**Changes to Support UFTR
Relicensing Application:
Technical Specifications**

University of Florida Training Reactor
Facility License R-56, Docket No. 50-83

CHAPTER 14

Figure 6-1 UFTR Organization Chart

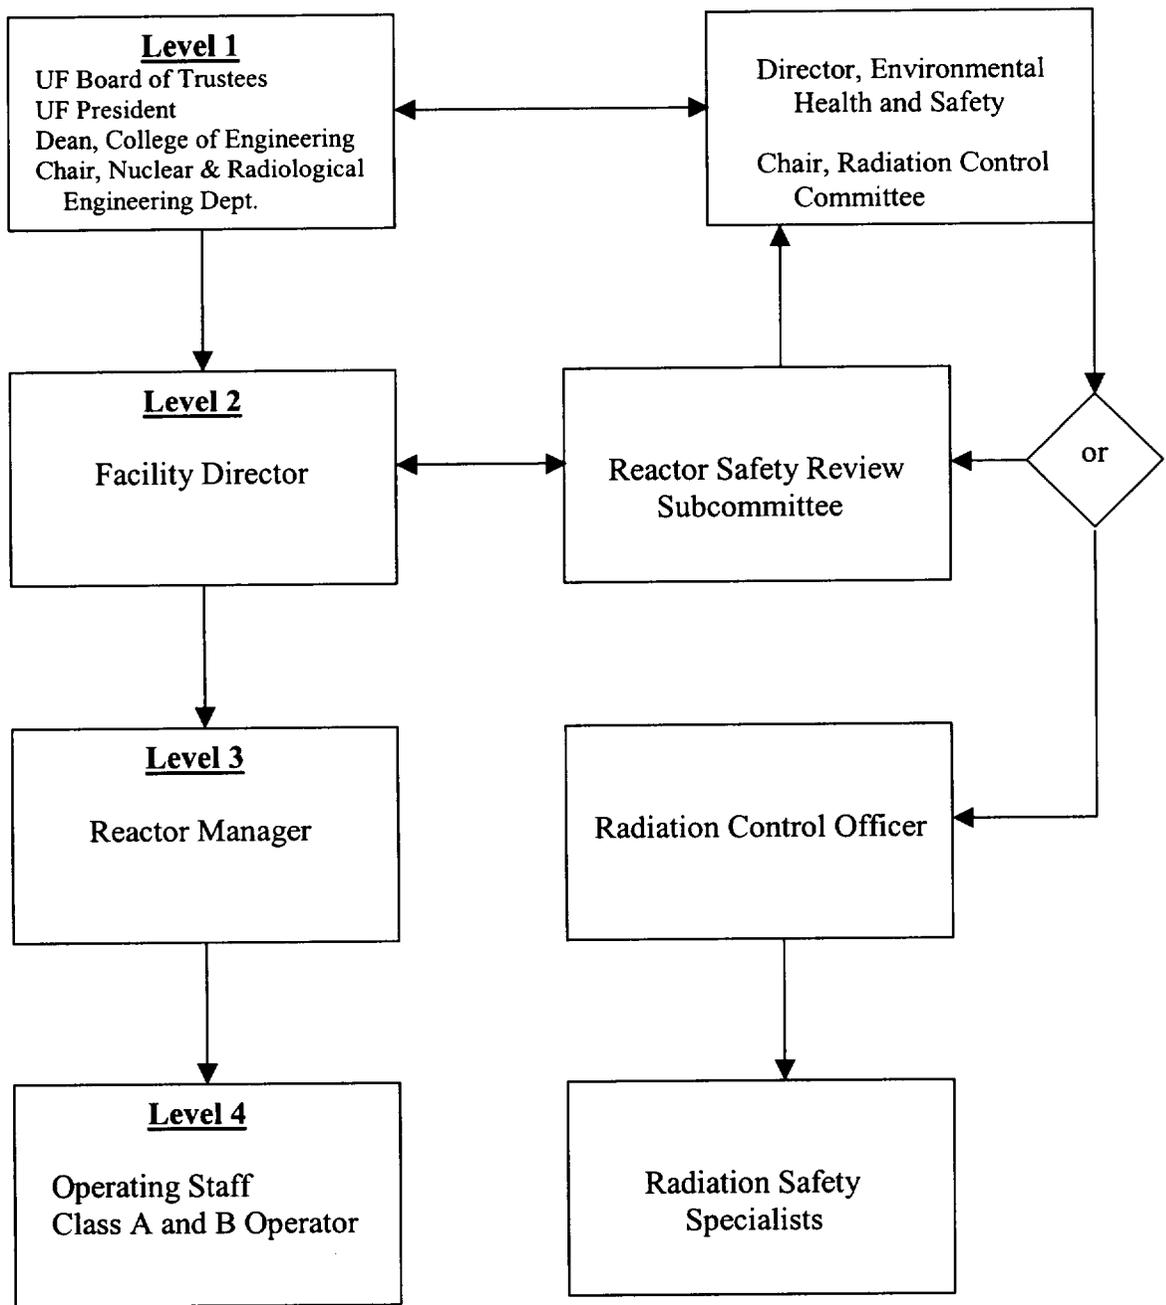
Eleventh, in Figure 6-1 UFTR Organization Chart, the organization is updated to reflect the fact that the University of Florida has recently, on July 1, 2001, converted to operation under a Board of Trustees to whom the UF President reports versus the previous Board of Regents. The University's Office of General Counsel indicates that this is now the proper way to present the UFTR Organization Chart though the Dean of the College of Engineering remains the effective Level 1 administrator for overseeing the reactor.
